WAYZATA PLANNING COMMISSION

Monday, March 24, 2025

MEETING DATE: March 24, 2025	AGENDA ITEM: 5.a
TITLE: Consider Development Application for a Planned Unit Development (PUD) Concept and General Plans, a PUD Zoning District Amendment, a Shoreland Residential PUD/Conditional Use Permit (CUP), a Shoreland Impact Plan (SIP)/CUP and Design Review for 200 Lake St E	
PREPARED BY: Eric Zweber, Planning Consultant, Valerie Quarles, City Planner	
REVIEWED BY: Alex Sharpe, Community Development Director	
60 DAY DEADLINE: May 8, 2025

**Staff Report
Wayzata Planning Commission
March 24, 2025**

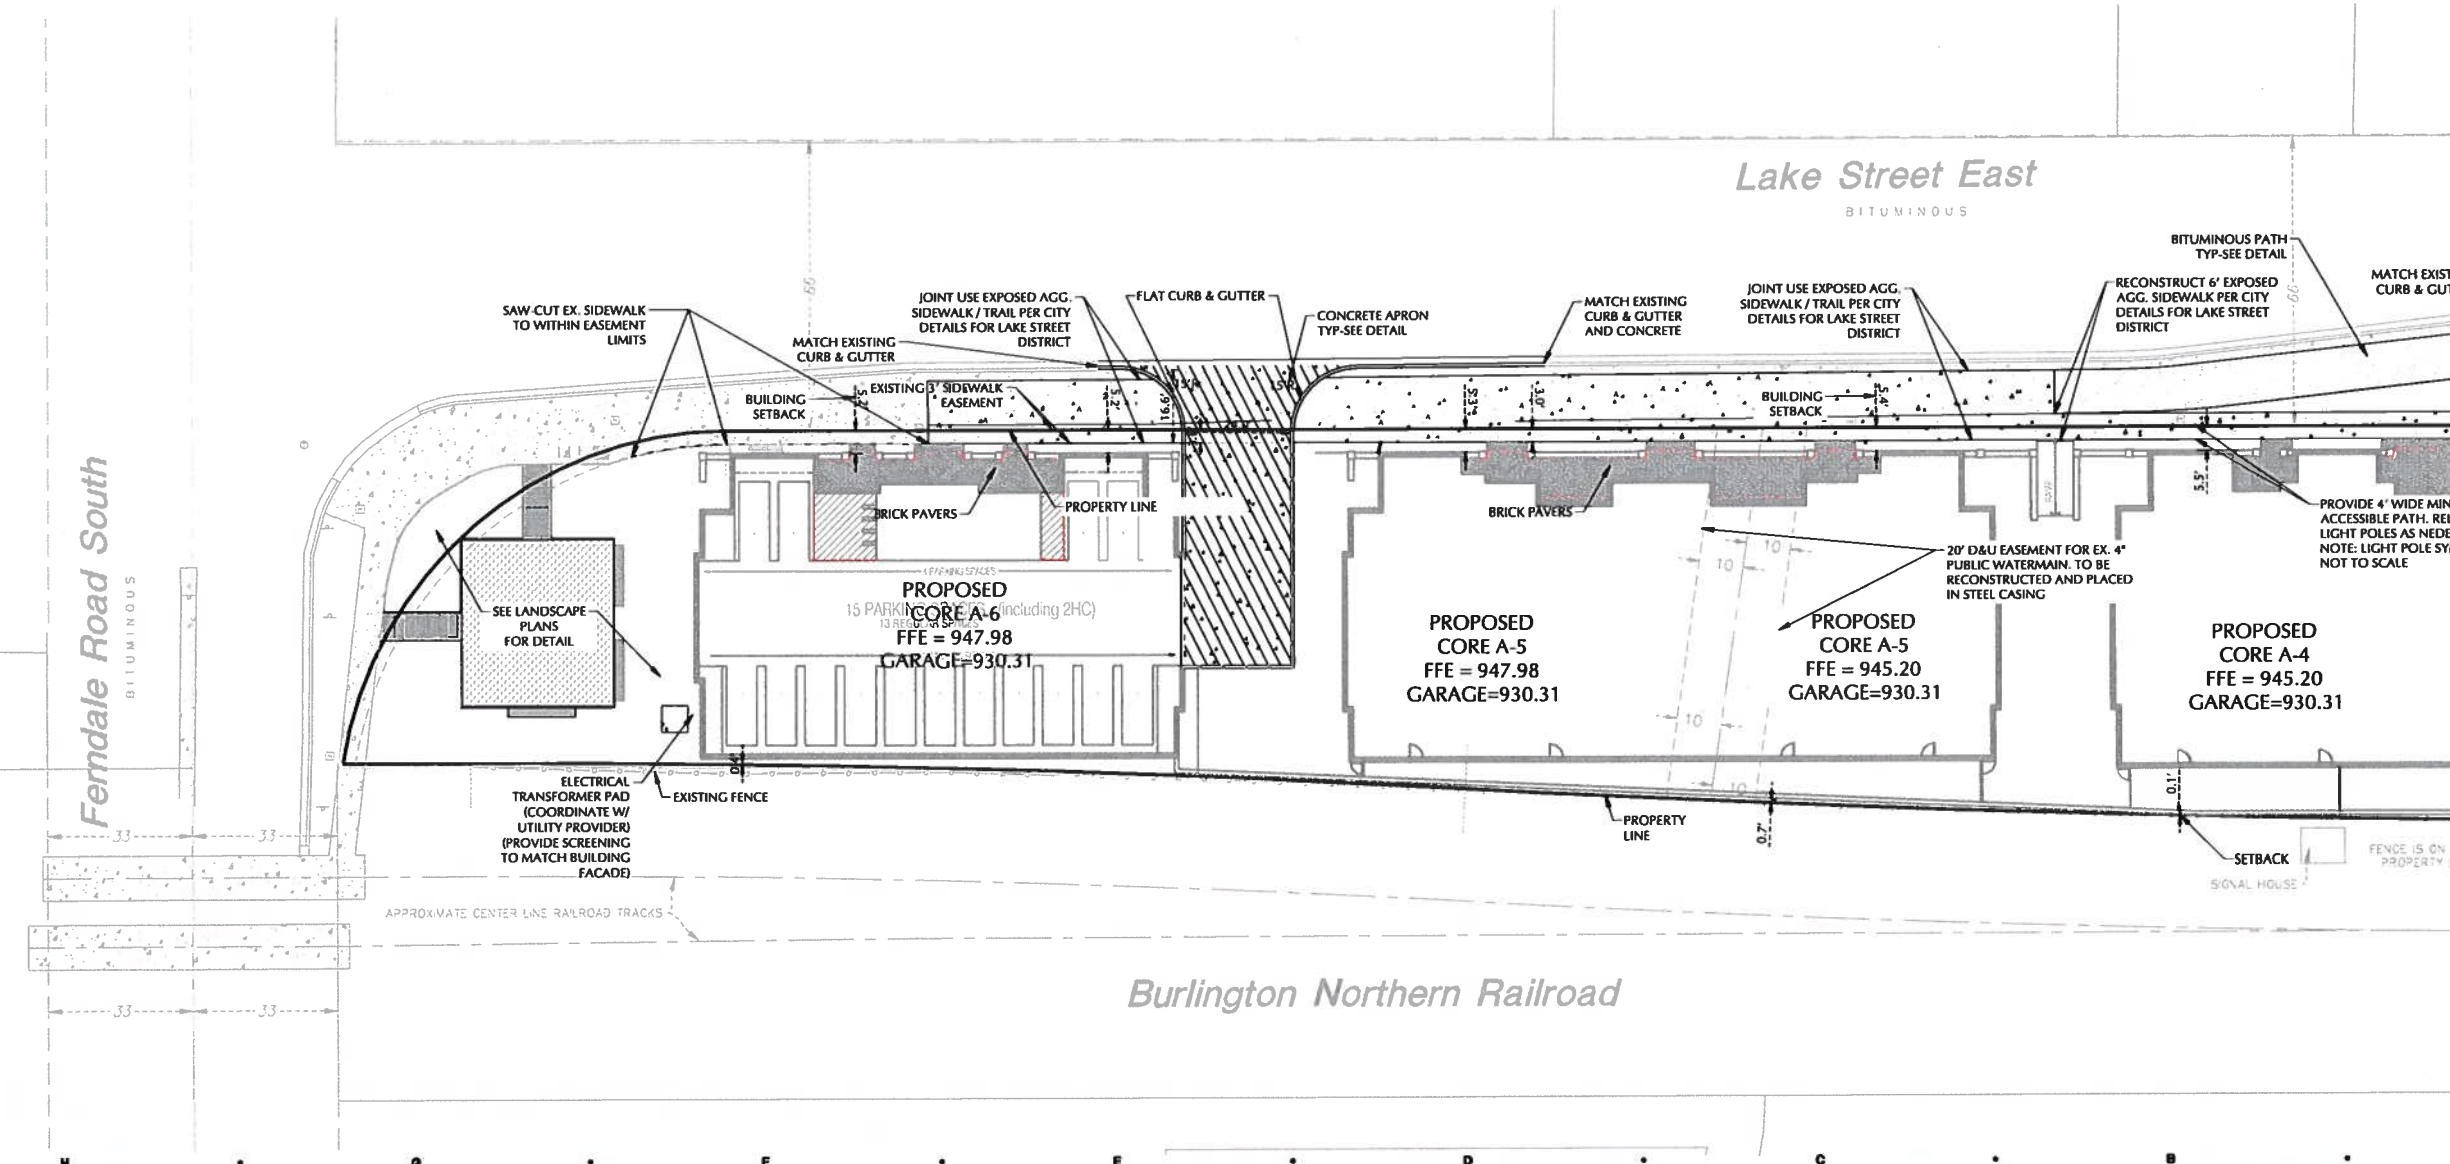
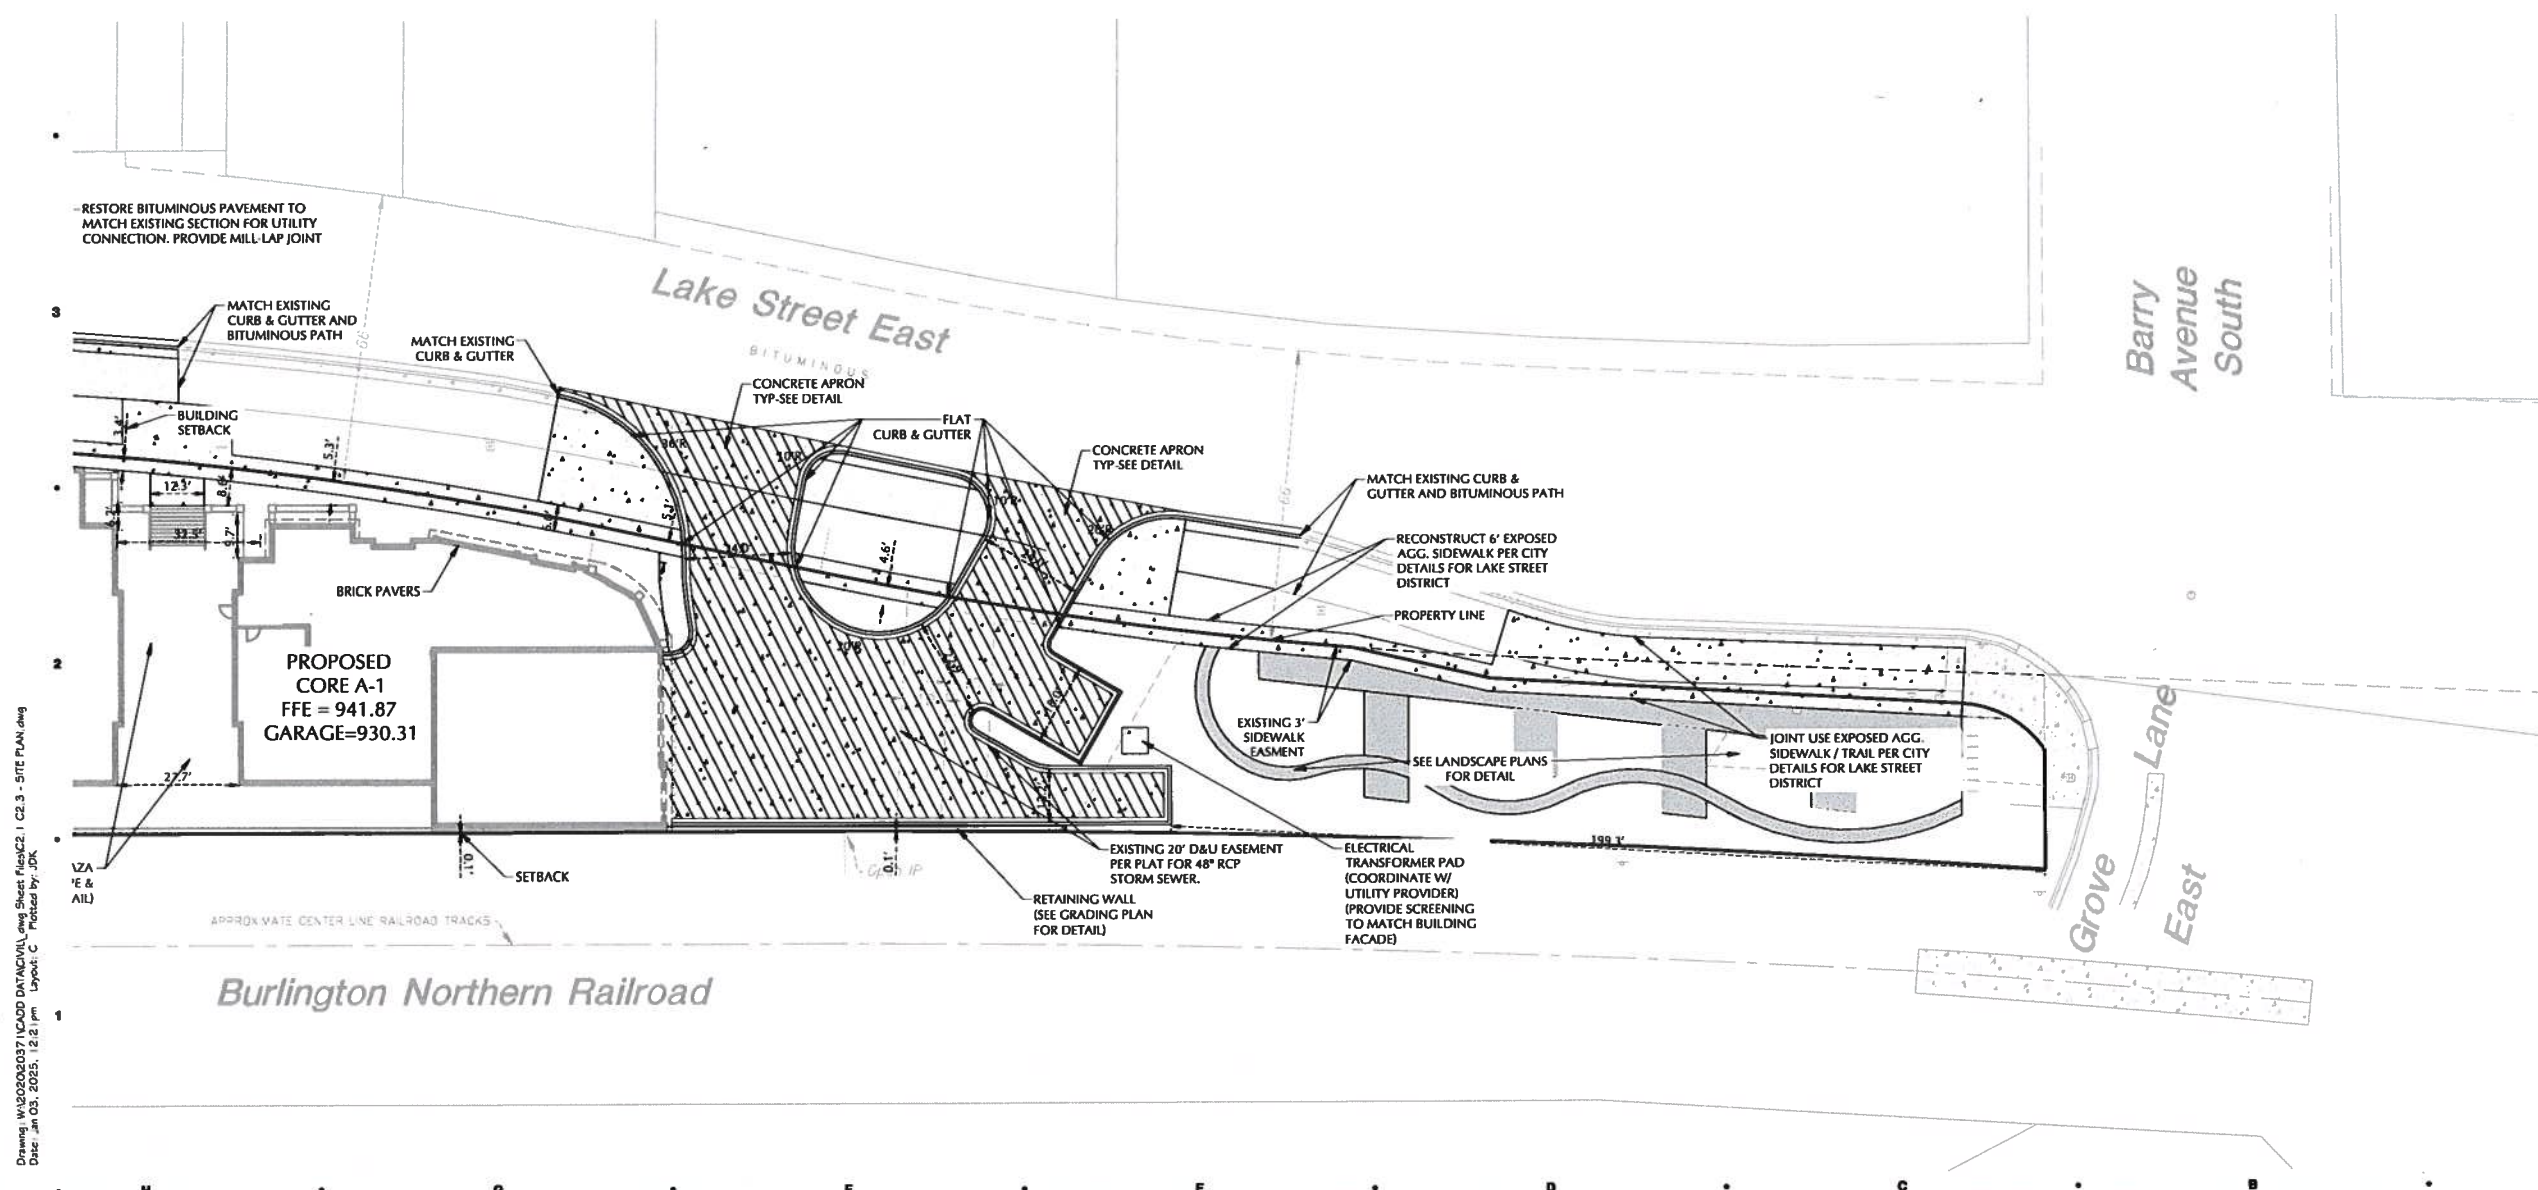
2. Civil Sheet C2.1 conflicts with Landscape Sheets L6 & L7. We want to visually separate the regional trail from the pedestrian sidewalk where we can. Therefore, we will require that the regional trail consist of bituminous pavement as shown on the Landscape plans, rather than a large joint-use sidewalk as indicated on the Civil plans.

- a. On sheet L7, the bituminous pavement should start where the bituminous is minimum 8' wide. See page 3 of the attached PDF mark-up for reference.
3. On Civil Sheet C2.3 and Landscape Sheet L2, the east end of the regional trail adjacent to the micro-park is shown as a joint-use sidewalk, versus separation of the trail from the sidewalk by a band of greenspace as it exists today. We believe the City's easements for a Mini-park, landscape and streetscape in this area allow the pedestrian sidewalk to encroach south of the property line, allowing us to maintain this separation, which will be critical given the potential pedestrian activity that will occur in this area.
